**MEETING OF THE  
TECHNICAL COMMITTEE ON  
RESPIRATORY PROTECTION EQUIPMENT**

**July 19-21, 2011**

**AGENDA**

1981, Log 7, Figures 1A, 1B, 2A, 2B, 3, 4

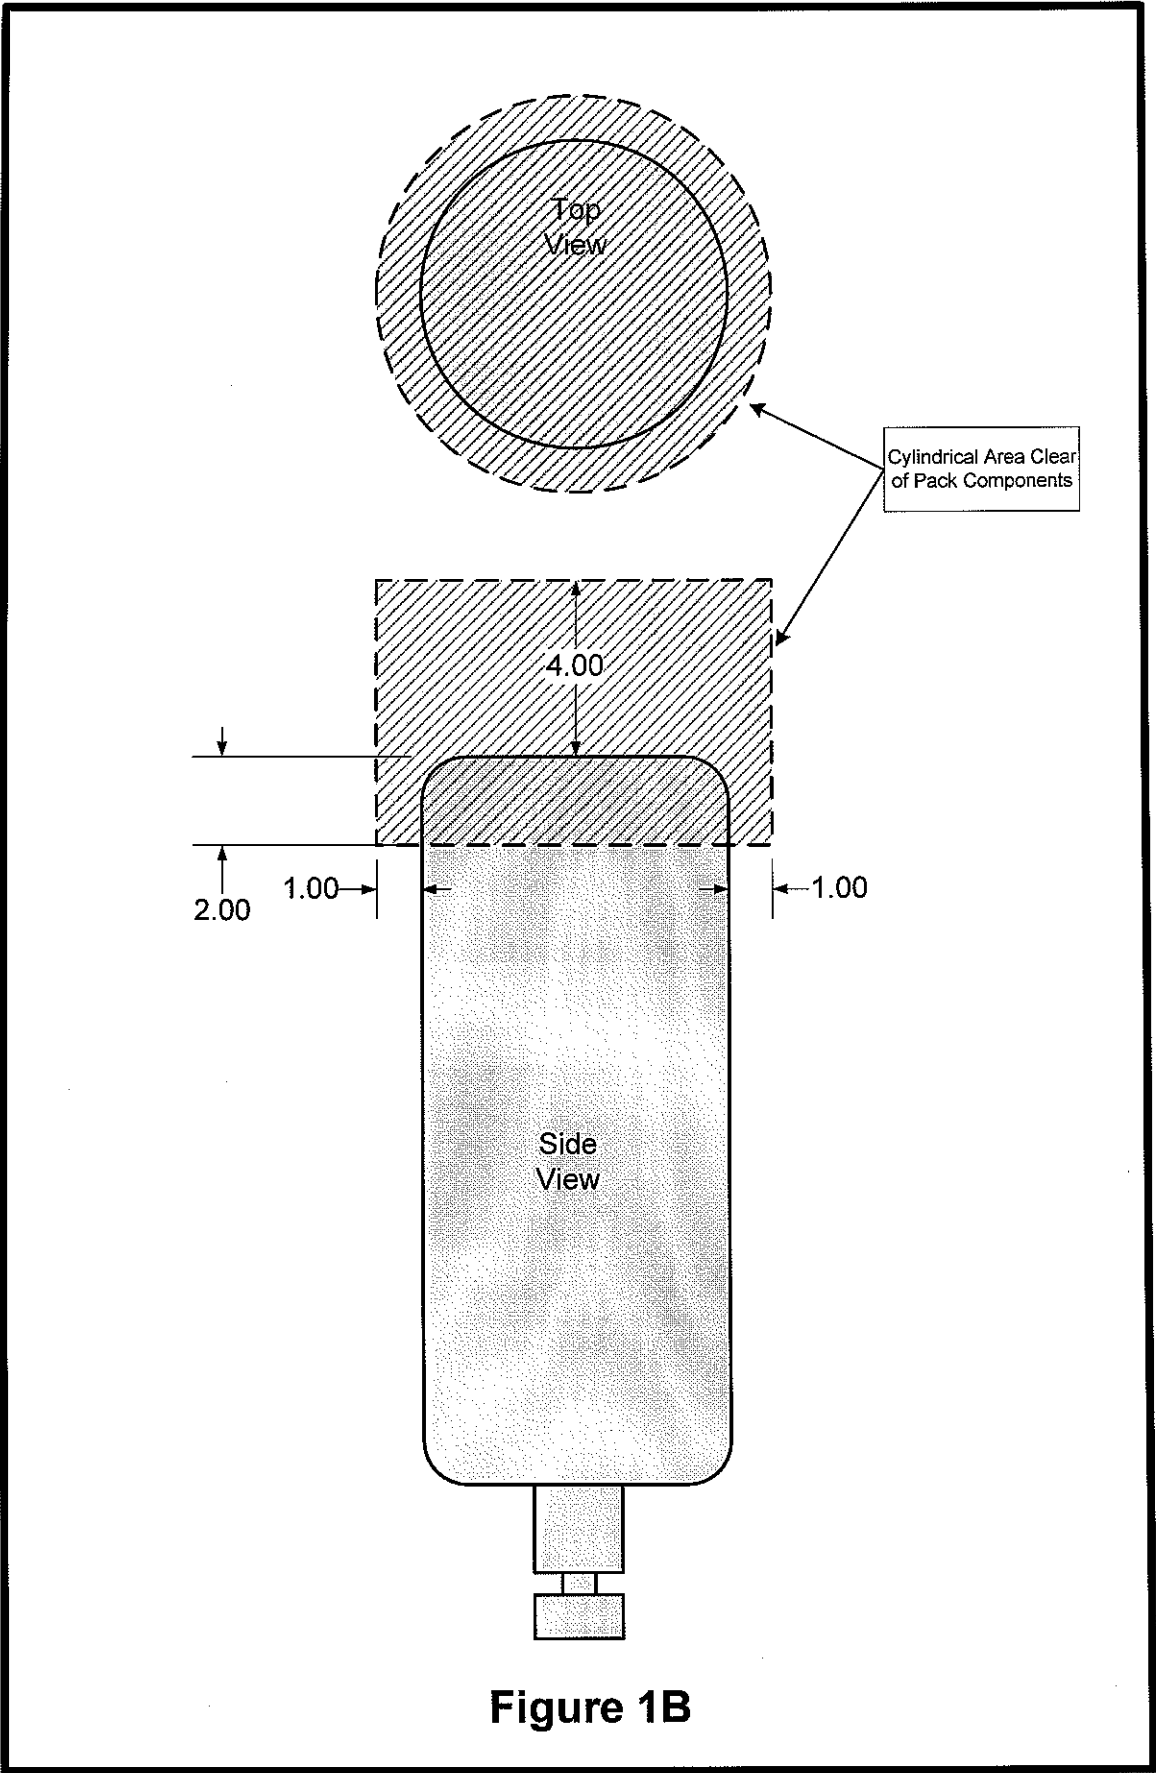
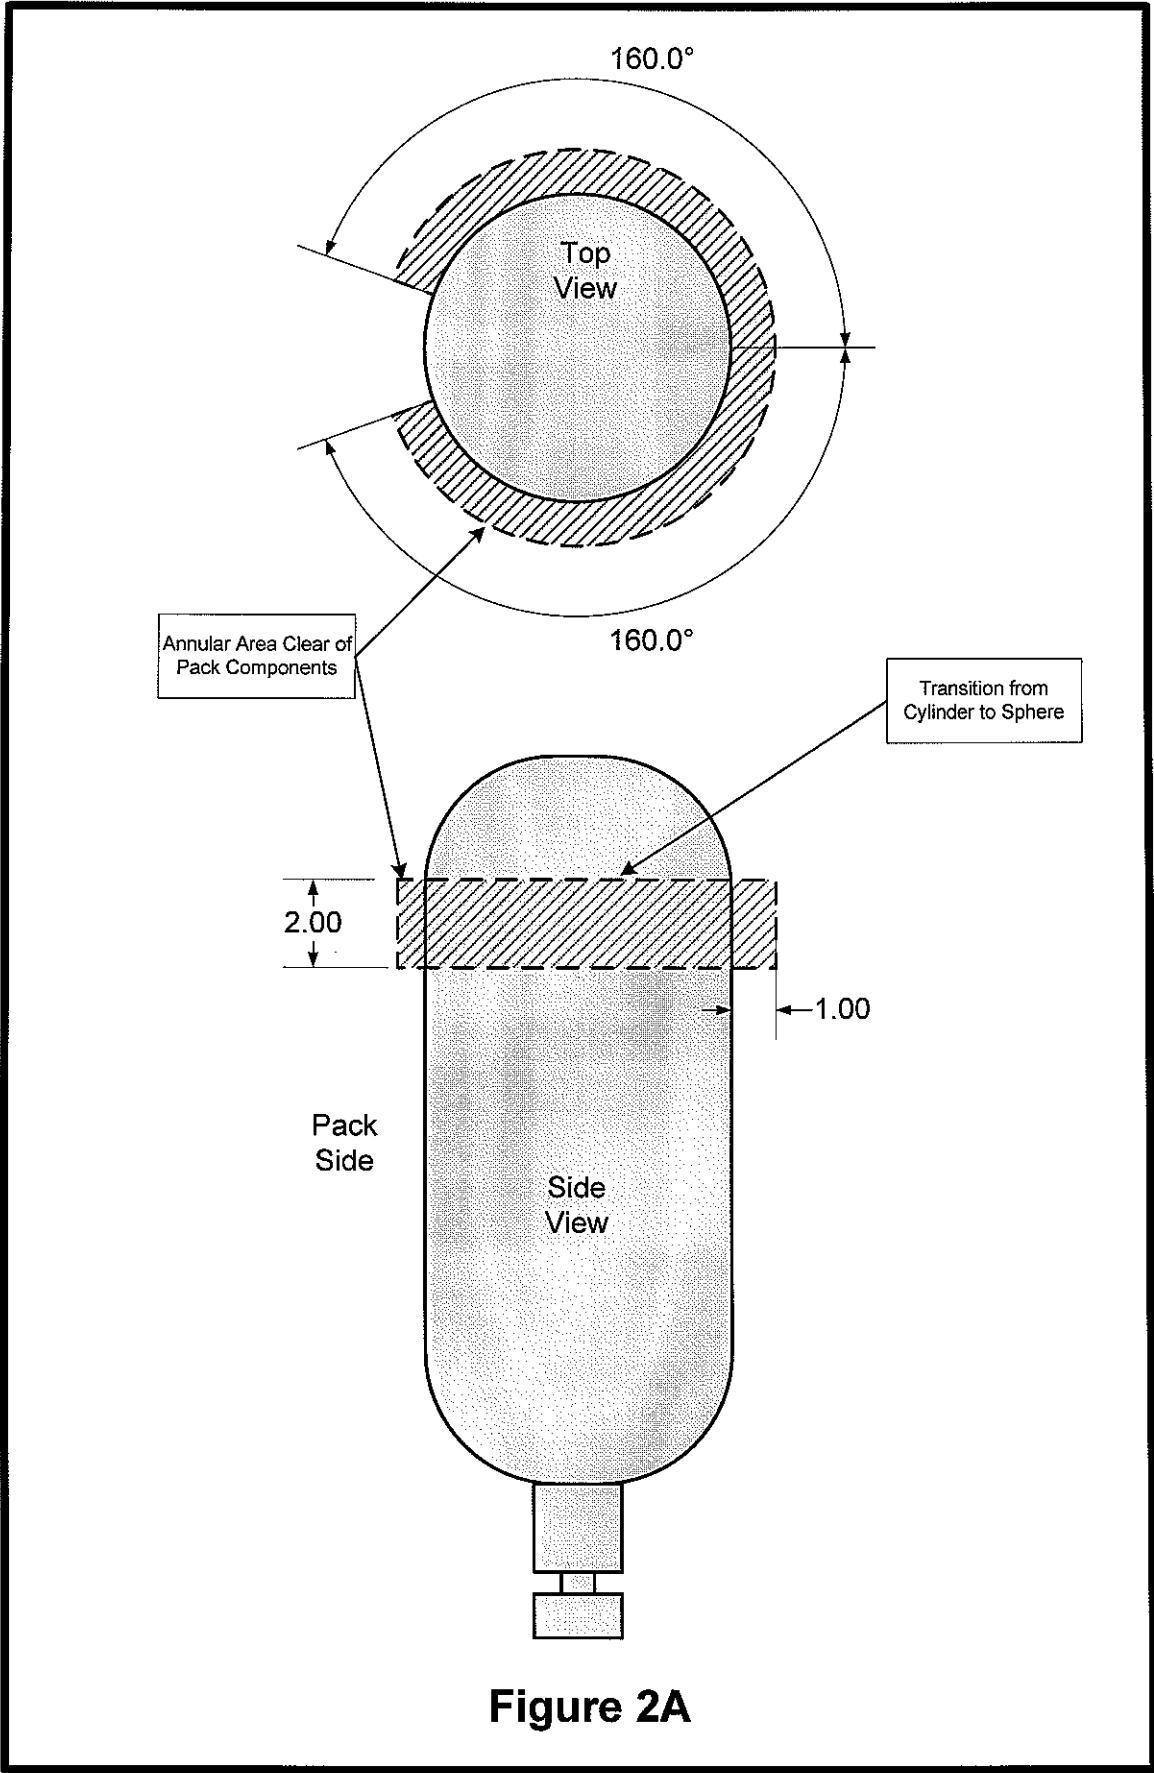
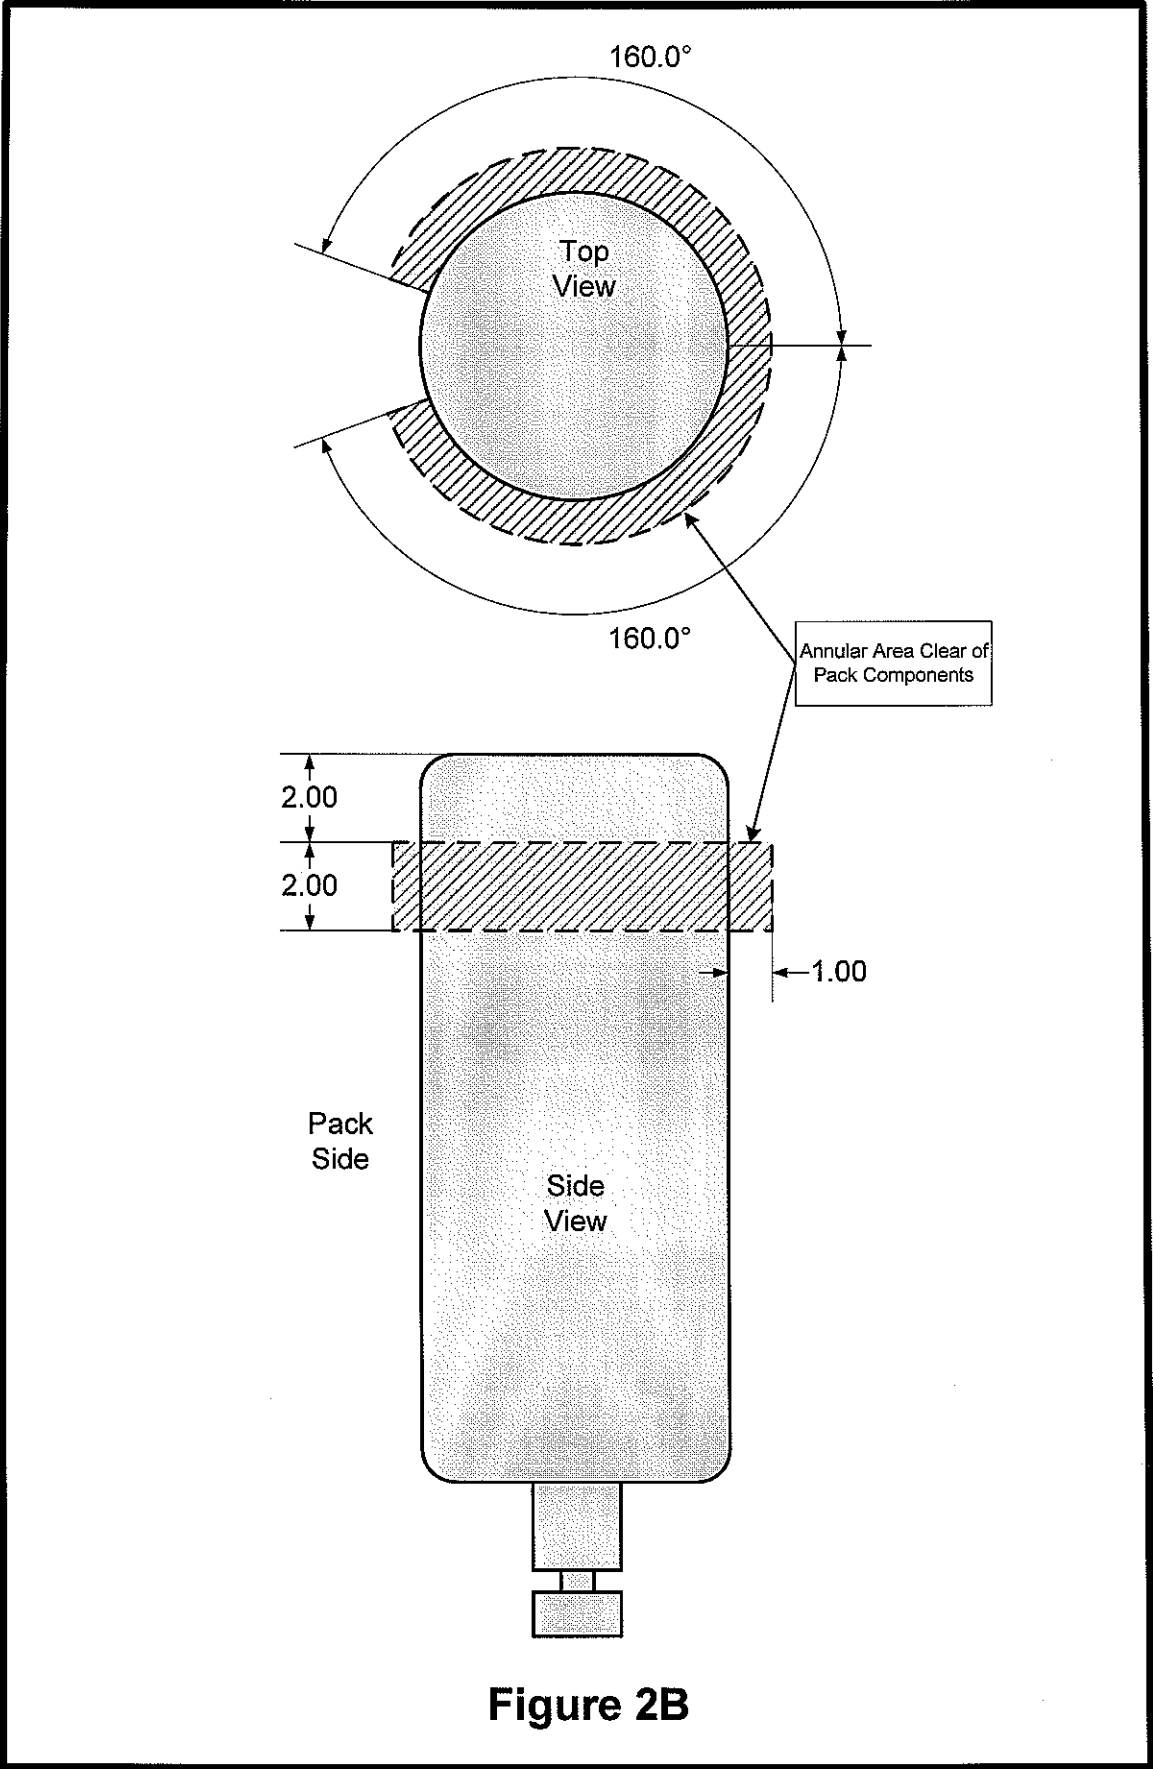
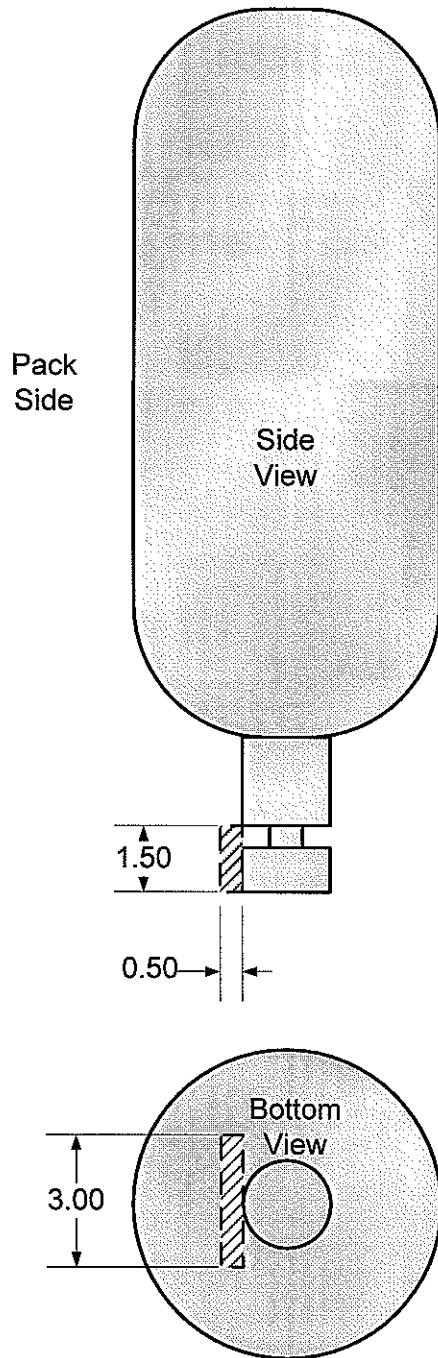
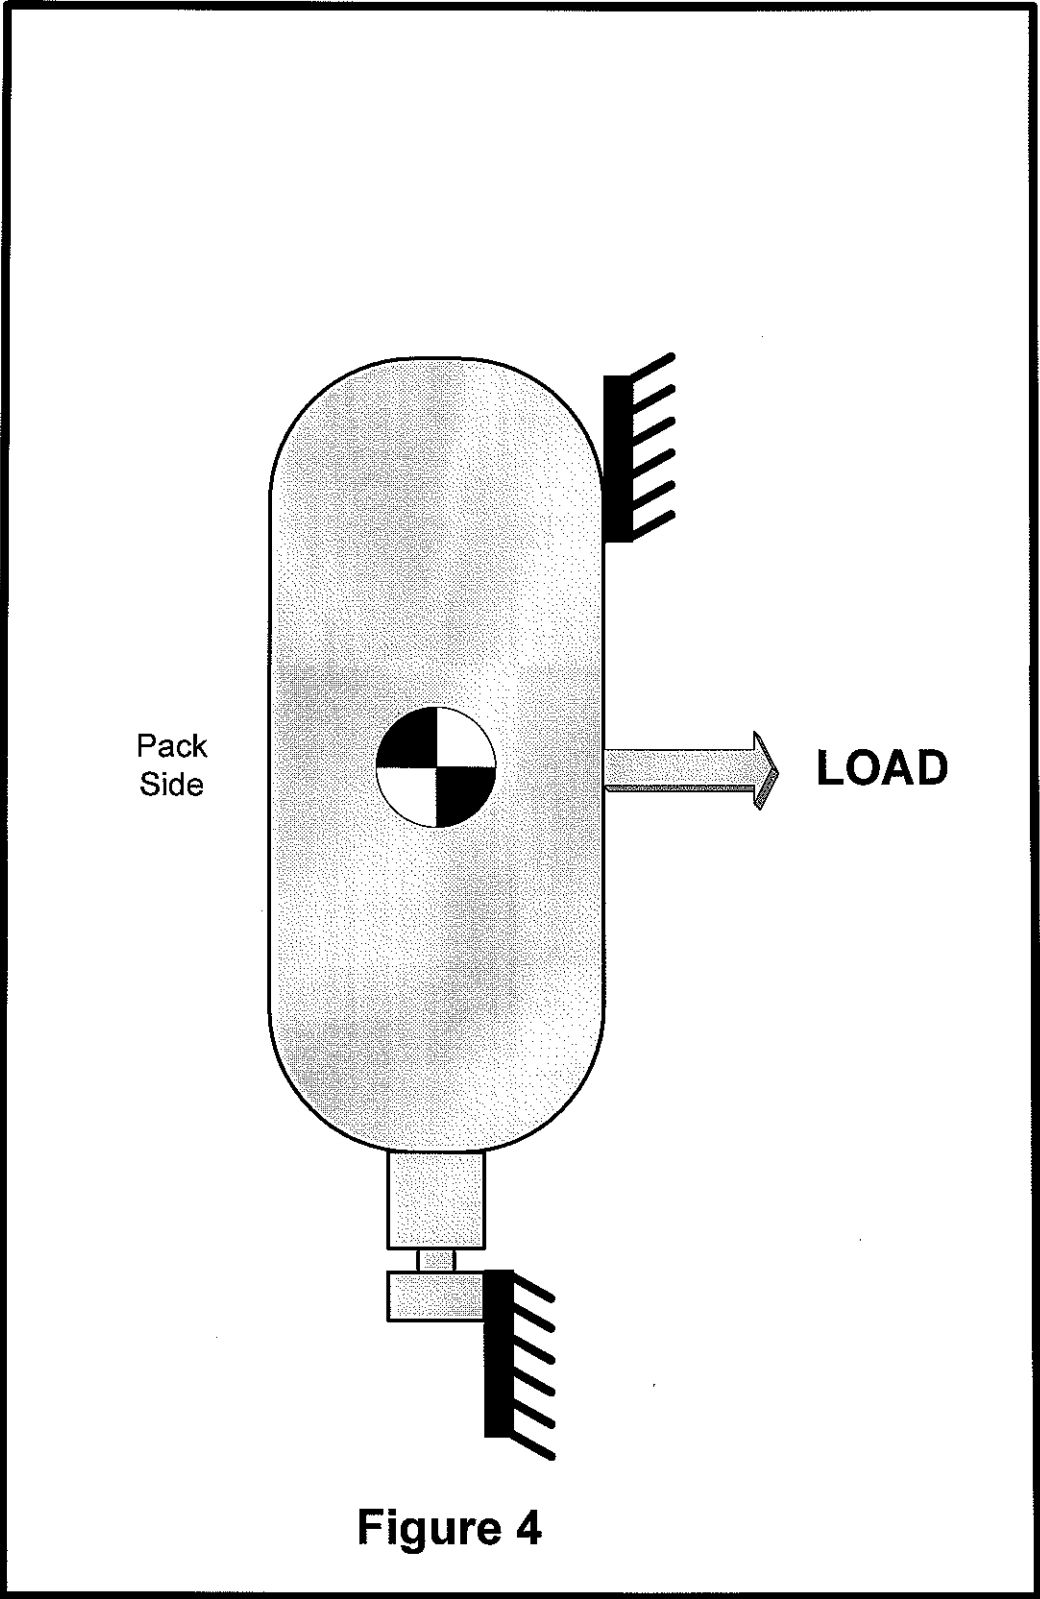
6.7.1 Each SCBA shall maintain a space at the top of the bottle that is clear of all obstructions for retention devices that grab the top of the bottle. This space shall be bounded by a cylindrical volume concentric with the bottle and one inch greater in radius than the bottle radius. For a cylinder with a dome shaped top this clear area shall begin 1 inch below the point where the spherical top of the bottle transitions into the cylindrical body of the bottle (see fig. 1A). For a cylinder with a flat top, this clear volume shall begin 2 inches below the top of the cylinder (see fig. 1B). Each clear volume shall be preserved for at least 4 inches above the top of the bottle.

6.7.2 Each SCBA shall maintain a space near the top of the bottle that is clear of all obstructions for retention devices that grab around the body of the bottle. This space shall be bounded by an annular volume concentric with the bottle, 1.0 inch greater in radius than the bottle radius, and 2.0 inches in height beginning at the back of the SCBA bottle and sweeping 160 degrees both clockwise and counterclockwise around the bottle. For a cylinder with a dome shaped top this clear volume shall begin 1 inch below the point where the spherical top of the bottle transitions into the cylindrical body of the bottle (see fig. 2A). For a cylinder with a flat top, this clear volume shall begin 2 inches below the top of the cylinder (see fig. 2B). This volume may overlap with the volume specified in paragraph 6.7.1.

6.7.3 The bottle valve (or other lowest component) of each SCBA shall include a vertical surface with a volume on the side of the bottle where the pack is mounted that is clear of obstructions to accommodate a retention tab. This space shall be bounded by a rectangular prism that is 1.5 inches high beginning at the bottom of the valve, 0.5 inches deep from the face of the valve, and 3 inches in width centered on the valve (see fig 3).

6.7.4 Each SCBA pack shall be attached to the cylinder and constructed in such a manner that the SCBA can be extracted from a retention device with a force of 80 lbs without damaging the pack straps or frame for the expected life of the SCBA.

6.7.5 The SCBA bottle valve shall remain attached to the bottle without damage when a force of 20 times the weight of the bottle and pack is exerted at the CG of the SCBA for 10 seconds with the SCBA being retained by a fixture that grips the top of the bottle and the extreme end of the valve (see figure 4).
